June 5, 2007

Monticello Nuclear Generating Plant
Docket 50-263
License No. DPR-22

Response to Request for Additional Information for the License Amendment Request:
Revision to the Allowable Values and Surveillance Intervals for the Low Pressure
Coolant Injection Loop Select Logic Time Delay Relays (TAC No. MD4095)

NRC Request for Additional Information

Figure 14.7-12 LPCI Initiation Logic

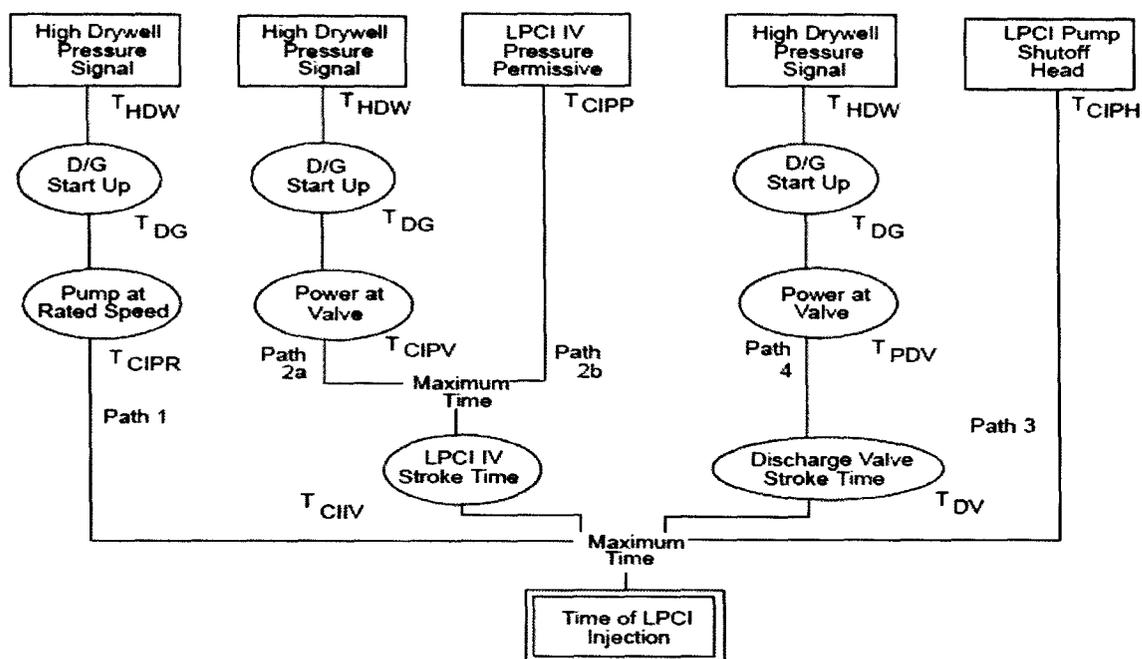
- (1) **The second paragraph of Section 5.3 of Enclosure 1, in part, states: "The LPCI [Low Pressure Coolant Injection] loop select time delay relays have very specific functions which do not specifically relate to accident timing parameters, Analytical Limits are not readily apparent." In addition, the second paragraph of Section 5.2 states: "In MODES 1, 2, and 3, operation of the LPCI loop select logic functions is required to ensure that no single failure can prevent successfully selecting the unbroken recirculation loop for LPCI injection." Since LPCI mode of the Residual Heat Removal system is one of the Emergency Core Cooling Systems, please provide the analyzed value of the time available to achieve successful LPCI injection so that the Nuclear Regulatory Commission (NRC) staff can determine that adequate margin is available in the setting of the time delay relays with or without loss of offsite power.**

Updated Safety Analysis Report (USAR) Section 14.7.2.3.3 discusses ECCS equipment performance. USAR Figure 14.7-12, presented below, depicts schematically the LPCI System initiation logic. The maximum of the time required to complete each of several parallel event sequences determines the LPCI injection time. The time required to complete each path is a combination of initiation signal and equipment parameter times. The times at which initiation signals occur depend on the vessel blowdown and break flow rates which are functions of break location and size. ECCS equipment parameters used in the

MNGP ECCS performance licensing analysis are listed in the USAR.⁽²⁾ The path nomenclature of Figure 14.7-12 was applied below to describe the parallel operations that occur.

No separate path is identified for the LPCI loop select logic time delay relays since they perform their functions in parallel within some of the paths (primarily Paths 2a and 4) described below. The LPCI loop select logic is initiated by the same signals that initiate the Diesel Generator start sequence. Diesel Generator (DG) startup is assumed to take 15 seconds in the analysis. Since the divisional LPCI loop select logic is powered from the 125 Vdc electrical system, it does not rely on AC power from the respective division's DG in order to complete its function.

1. LPCI pumps at rated speed (Path 1). For this to occur, the DG must be started and powering the emergency busses. Low Pressure Coolant Injection pumps are loaded on the emergency busses and achieve rated flow.

The ECCS-LOCA evaluation uses 34.3 seconds as the maximum time from initiating signal to LPCI pump at rated speed and capable of rated flow.

2. LPCI injection valves open (Path 2). Two conditions must be satisfied:
 - Power must be established at the valves (Path 2a). DG started and powering the emergency busses.

For the limiting large break LOCA, (the maximum recirculation suction line break with battery failure and nominal assumptions) the RPV depressurizes rapidly and the LPCI injection will occur following Paths 2a and 4. DG startup is assumed to take 15 seconds in the LOCA analysis with the LPCI loop select logic proceeding in parallel with the DG startup. The large break LOCA analysis indicates that RPV pressure falls below 900 psig within approximately 4 seconds into the limiting large break event. (If the unit was operating in SLO, Functions 2.k and 2.m cannot occur until the RPV pressure decreases to approximately 900 psig.) This leaves a remaining period of approximately 11 seconds for the LPCI loop select time delay relays to perform their function within the time for the DGs to start and provide AC power to the injection valves (Path 2a).⁽⁵⁾ Therefore, as long as the total time delay due to the LPCI loop select time delays relays is less than 11 seconds, the timing of the LPCI injection assumed for a large break event in the LOCA analysis will not be affected. For this event, injection occurs at approximately 54 seconds.

For the limiting small recirculation line break LOCA, (the 0.08 ft² recirculation line break case with battery failure and Appendix K assumptions) the RPV depressurizes much more slowly and the LPCI injection occurs following Paths 2b or 3. (Note that the injection time for these events depends on the rate of depressurization which depends on the break size and location of the break being evaluated. Depending on the break size, LPCI injection may be further delayed until the RPV pressure reduces to below the LPCI pump shutoff head, Path 3.) For this limiting Appendix K small break in the latest ECCS-LOCA analysis, LPCI injection occurs at greater than approximately 450 seconds into the event and hence a much longer time is available for the LPCI loop select time delay relays to perform their function.
